**Sandyford Business District
Cycle Infrastructure Review**

Localised Issues

P18-055-DG-004

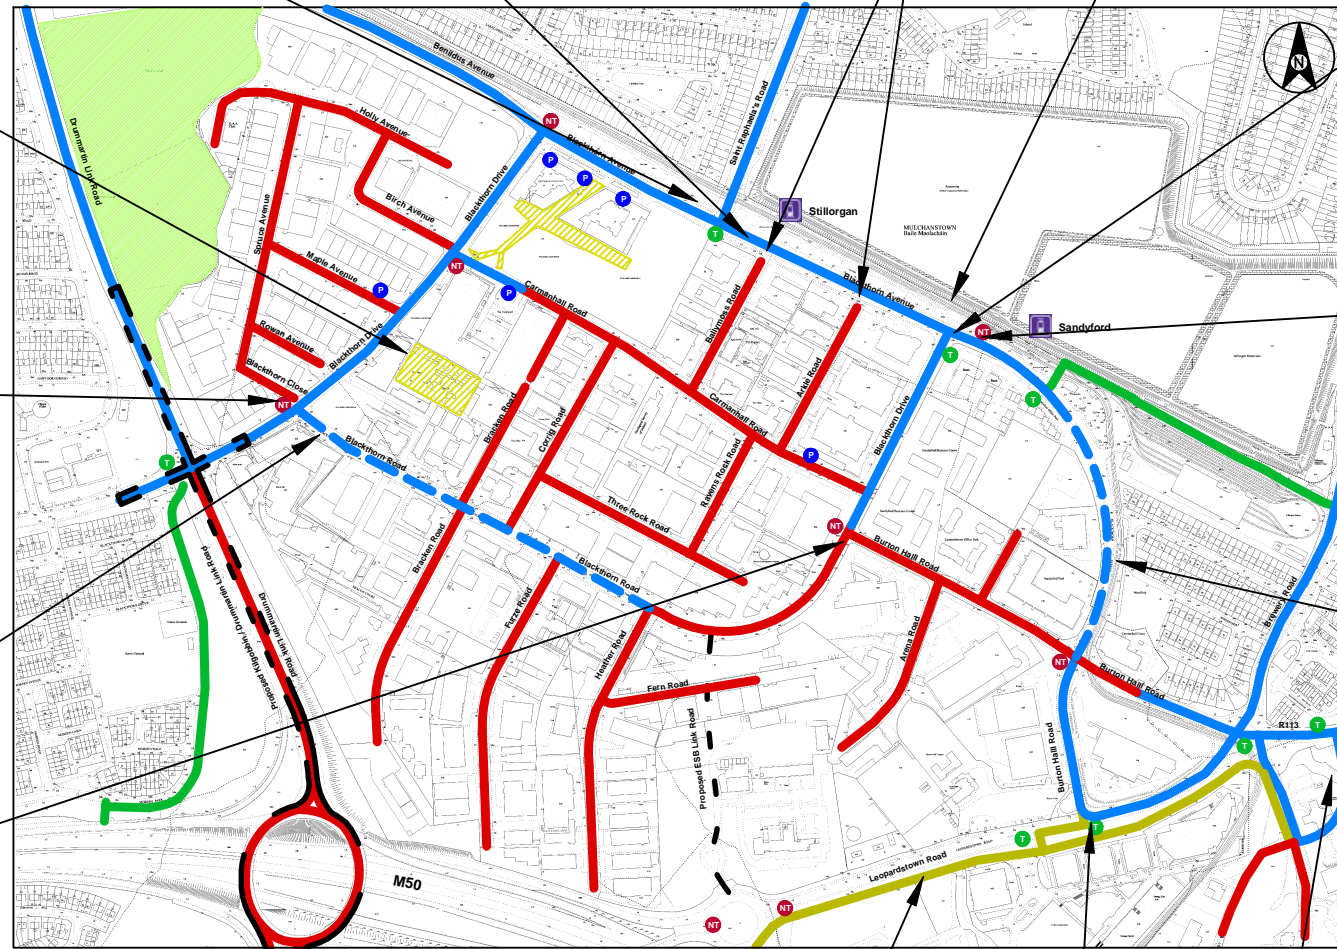
Cyclists can access Beacon shopping centre at a number of locations with bicycle parking stands provided. The entrance from Blackthorn Drive provides ramps which may be used by cyclists. It is unclear if the gradient is too steep for cyclists who may become fatigued on the incline.

No access to Blackthorn Close from Blackthorn Drive is provided.

High Volumes of traffic identified travelling north on Blackthorn Road to its junction with Blackthorn Drive. Vehicles were identified blocking the cycle lane resulting in cyclists weaving through live traffic and using the footpath to continue their journey.

Bicycles informally parked at junction. This may result in a reduced footpath width and pedestrians walking on uneven surfaces.

No signal head has been provided to alert westbound cyclists on Blackthorn Avenue to pedestrian green phase.

Vehicle speeds on Blackthorn Avenue were considered high with vehicles encroaching the existing cycle lane. As a result, less confident cyclists may not use the existing facilities.

Access to Arkie Road and Ballymoss Road from Blackthorn Avenue not provided and pavement failure identified on Arkie Road.

Verge shows signs of pedestrians walking along an uneven surface. Pedestrians may walk along cycle lane and force cyclists onto running carriageway.

A signal head pole is located in line of westbound cyclists as they attempt to cross at the Blackthorn Avenue/Blackthorn Road junction.

No warning of shared use surface for westbound cyclists on the southern verge of Blackthorn Avenue.

Luas crossing for cyclists and pedestrians creates conflict point. Additionally, high volumes of cyclists identified using running carriageway.

Dropped kerbing at entrances on the northern verge of Leopardstown Road resulting in an uneven surface and poor ride quality for cyclists.

No pavement markings are provided to indicate two way cycle facilities. Pedestrians may encroach into cycle facilities.

The shared use area on the eastern side of Burton Hall Road at its junction with Leopardstown Road is insufficiently wide.

Unclear if cyclists are permitted through the public park area. Cyclists exiting onto Leopardstown Road are unable to access the existing cycle track as a result of a drop in the cycle track level from the footpath.

The gradient of the ramps should be further assessed and landings provided if necessary.

Provide a shared surface and access for cyclists wishing to access Blackthorn Close from Blackthorn Drive.

Provide an off road cycle track to ensure vehicles do not block cycle facilities.

Provide cycle parking stands at this location.

Provide a signal head to alert cyclists of pedestrians crossing.

Provide two-way off road cycle facilities on the southern verge of Blackthorn Avenue from its junction with Blackthorn Drive to the west and Burton Hall Road to the east

Provide a shared surface and access for cyclists wishing to access Arkie Road and Ballymoss Road from Blackthorn Avenue

Provide measure to remove the risk of pedestrians walking along the roadside edge at the Luas park and ride facilities.

Relocate the pole to provide an unobstructed crossing for cyclists.

Provide sufficient warning for cyclists approaching the shared use surface.

Revise cycle facilities to remove conflict point between pedestrians and cyclists.

Provide continuous cycle track on the northern verge of Leopardstown Road giving priority to pedestrians and cyclists at residential accesses with a maximum kerb height of 25mm.

Provide road markings and signage along cycle facilities to ensure pedestrian and cyclists are aware of existing arrangement.

The site boundary on the eastern side of Burton Hall Road should be as part of any proposed development scheme in the existing disused site.

Provide access for cyclists to and from the public area from the cycle track provided on the southern verge of Leopardstown Road.
